Preliminary/ **FINAL DRAINAGE REPORT**

**MIDTOWN COLLECTION AT HANNAH RIDGE  
FILINGS 1 AND 2  
(A Replat of Tracts AA and BB, Hannah Ridge at Feathergrass  
Subdivision Filing No. 1)**

PUDSP-19-004

**March 2019**

MIDTOWN COLLECTION AT HANNAH RIDGE FILING NO. 1 DEVELOPED CONDITIONS DRAINAGE MAP			
DESIGNED BY	KRC	SCALE	DATE 03/22/19
DRAWN BY	LDB	(H) 1" = 30'	SHEET 1 OF 3
CHECKED BY		(V) 1" = NA	JOB NO. 1116.30

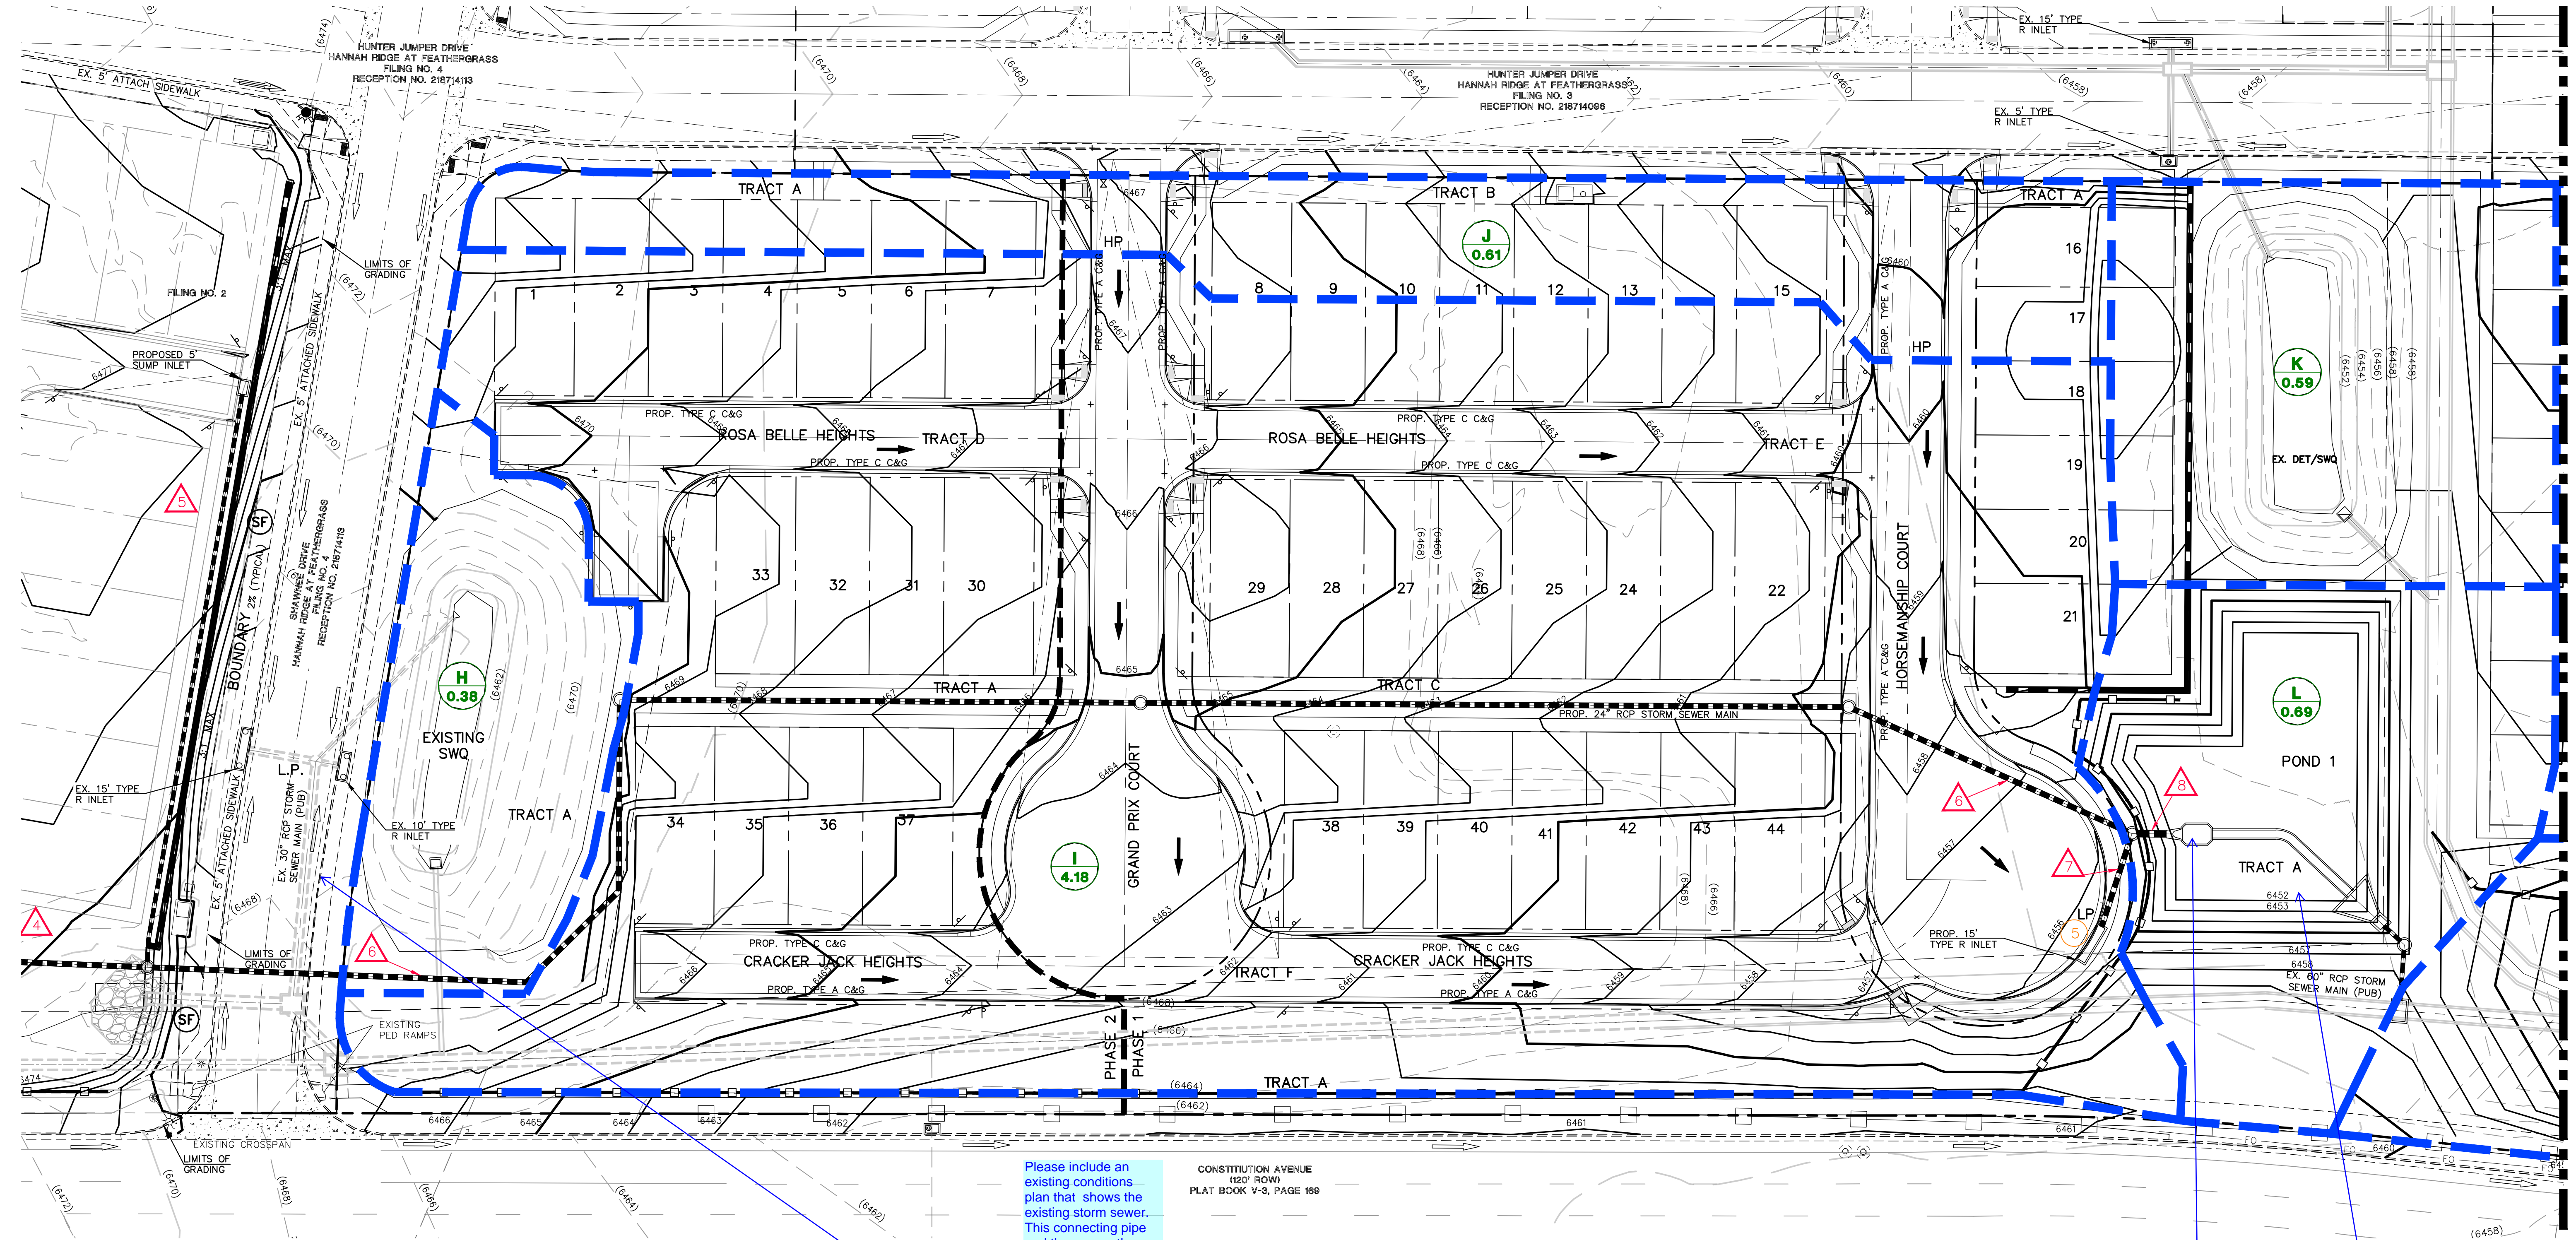
Provide "emergency conditions" analysis at this location. Address minimum finished floor elevation of Lot 45.

Provide pond attributes (actual volumes)

MIDTOWN COLLECTION AT HANNAH RIDGE FILING NO. 1 DEVELOPED CONDITIONS DRAINAGE MAP			
DESIGNED BY	KRC	SCALE	DATE 03/22/19
DRAWN BY	KC	(H) 1" = 30'	SHEET 2 OF 3
CHECKED BY	(V) 1" = NA	JOB NO.	1116.30

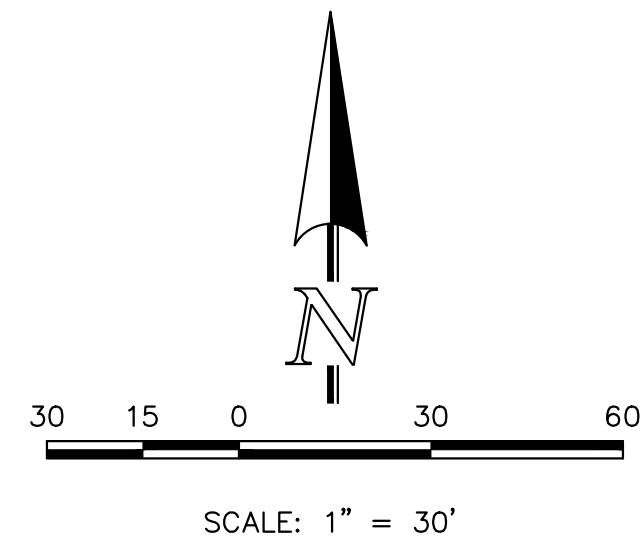
Please include an existing conditions plan that shows the existing storm sewer. This connecting pipe and the one on the previous sheet need to be shown. It is unclear how the storm gets captured in the existing SWQ facilities currently.

Show Design Point 8  
Provide pond attributes

DESIGNED BY	KRC	SCALE	DATE	03/22/19
DRAWN BY	LDB	(H) 1" = 30'	SHEET	3 OF 3
CHECKED BY		(V) 1" = NA	JOB NO.	1116.30

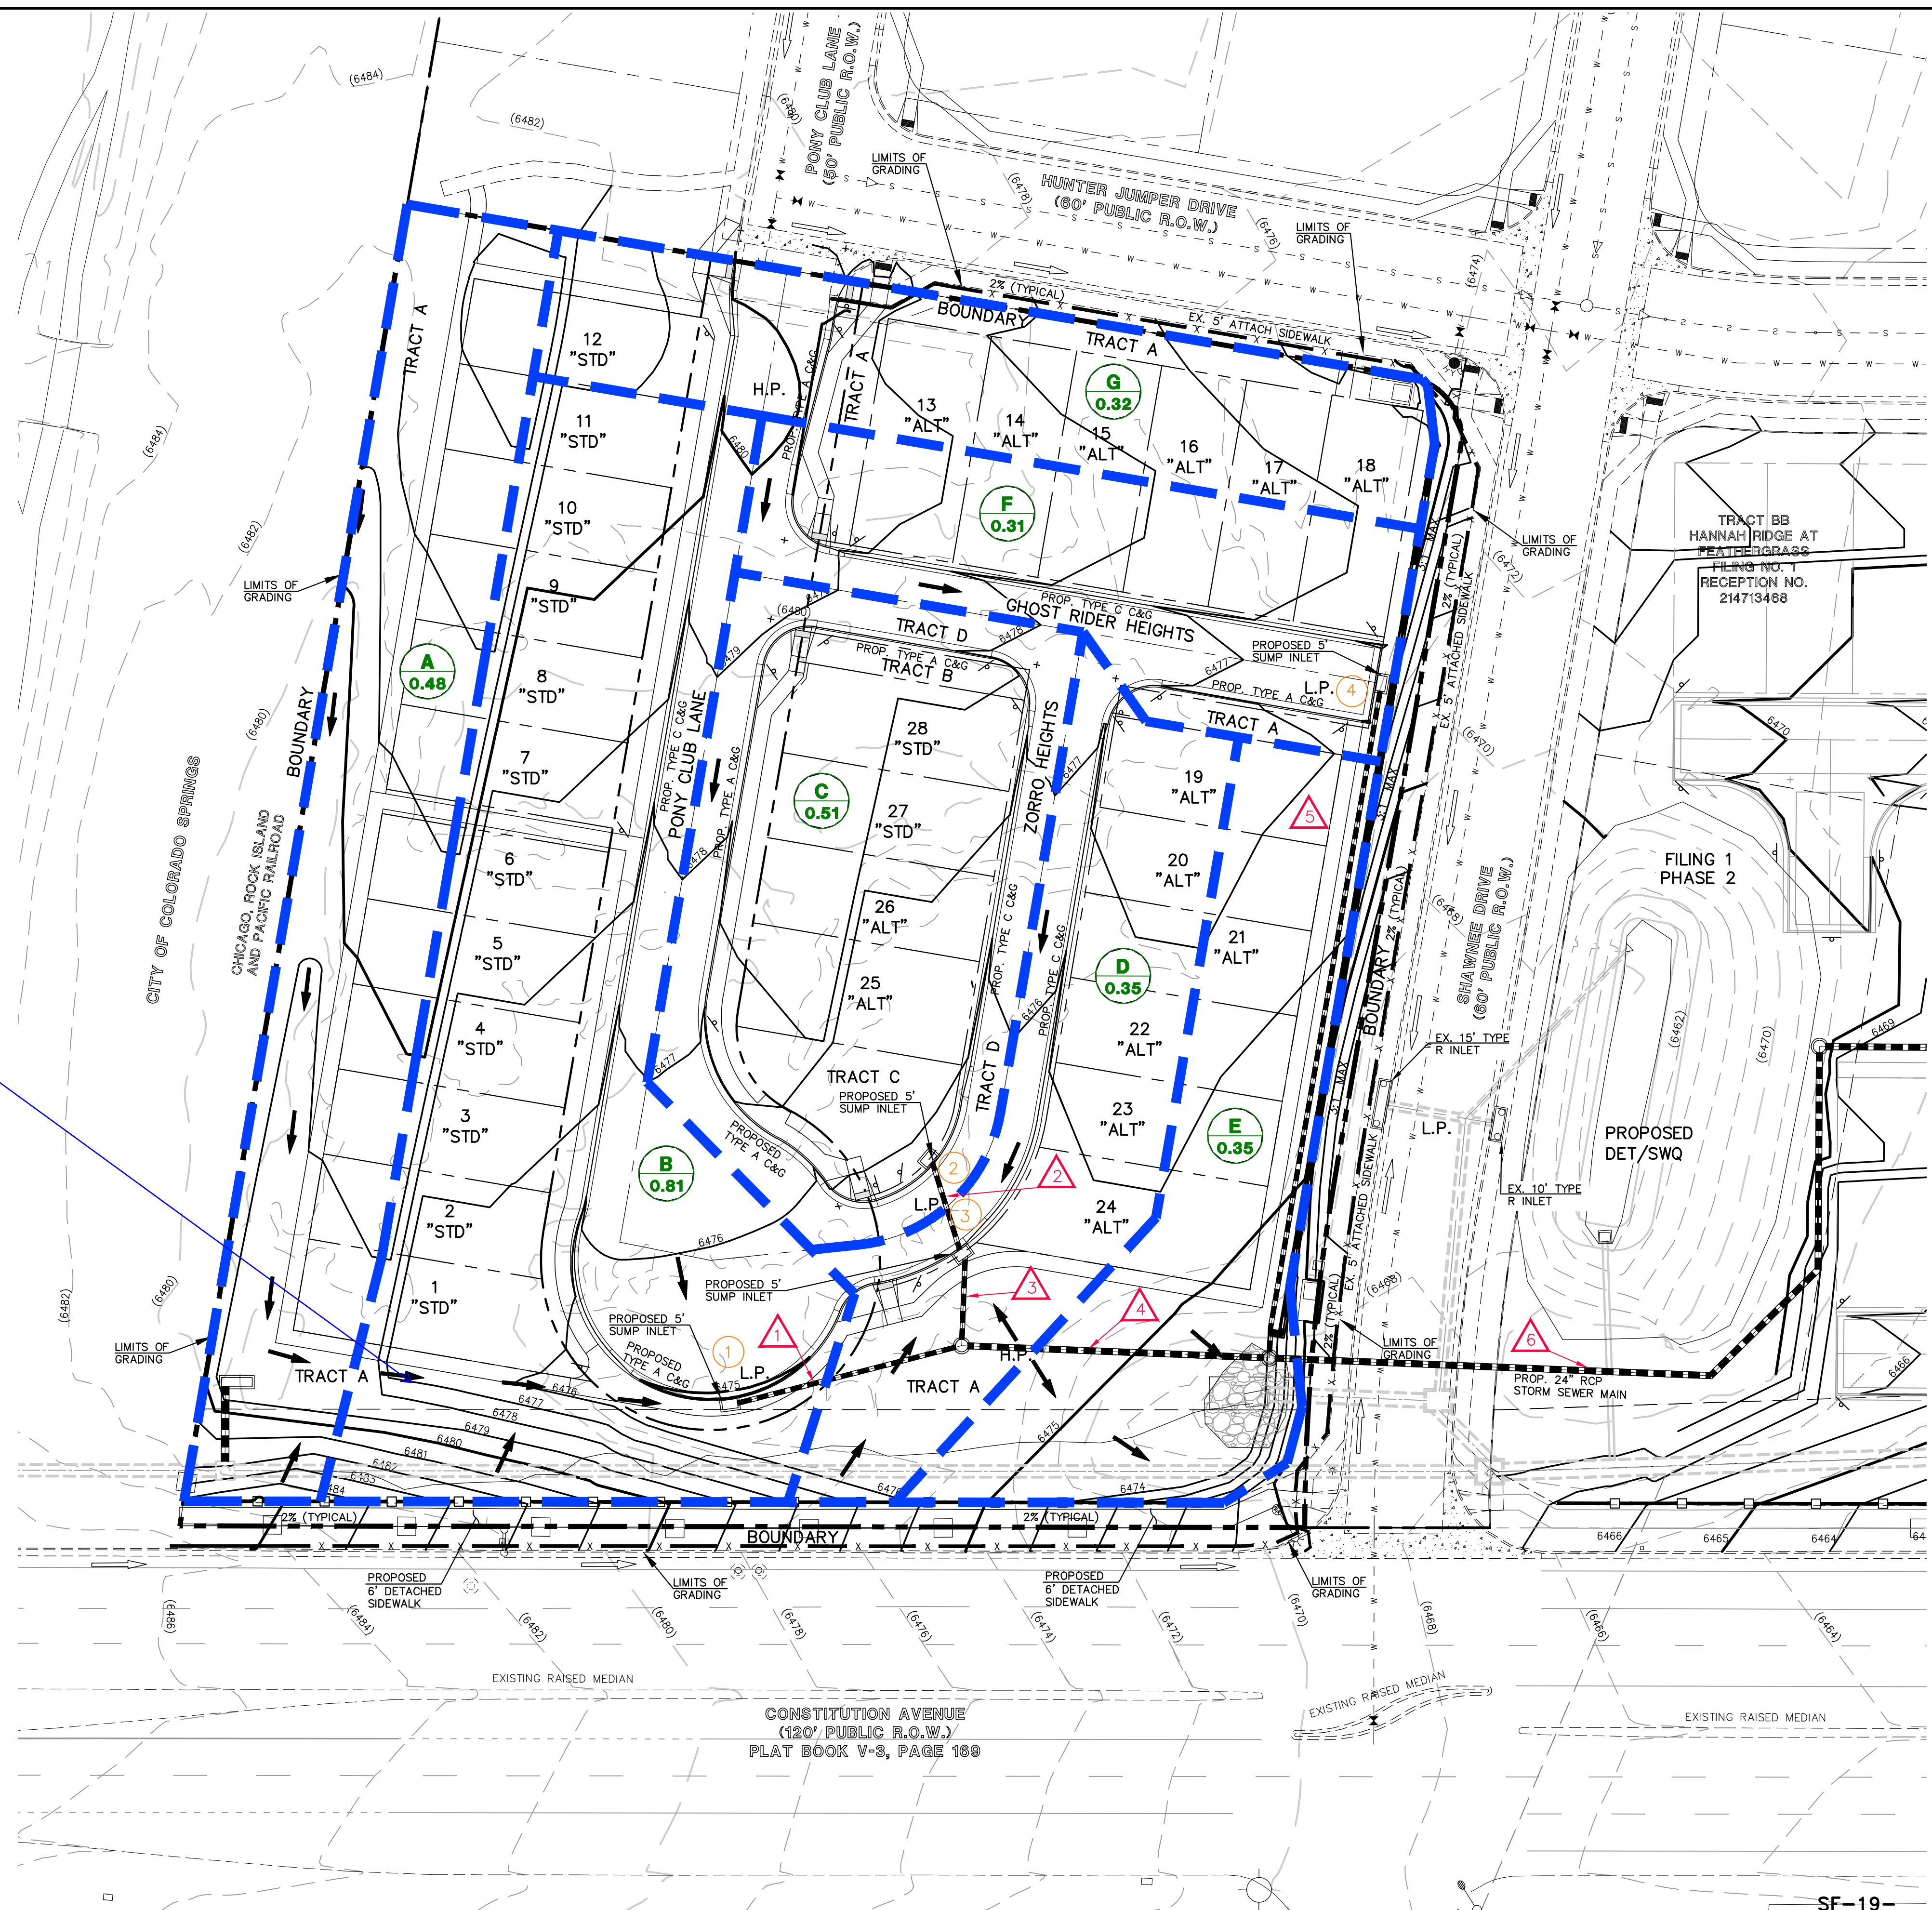
Provide a summary of all design points for all design flows. In a table, on these plans. Sheet 33?  
 Darken design points so they can be identified on a printed version.  
 Basin E needs to flow to a detention/SWQ Facility.

Show and label existing and proposed drainage easements.

If this is a swale show grading as such.
